**ALTO MAIPO****OWNER'S INSTRUCTION**  
Section 2.29  
PHAM-PLN12-INS-0003

Contract: <input type="checkbox"/> AM-CO610/620B <input checked="" type="checkbox"/> AM-CO630/620A	SI 6340 IN° 0093
Scope Segment Description: Pregrouting VL4	Scope Segment ID: 3.4.2
Location: VL4 Ch: 0+840,9	Time for Compliance: before next advance

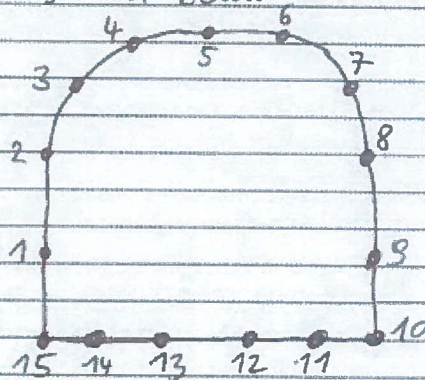
Do a pregrouting with 15 holes according to drilling sketch below:

Grouting pressure w-c ratio max. volume of cement according to attached plan "SAM-6340-TV-PLA-0001" - Revision A

If exceeding max. volume of cement approval needs to be requested at OE.
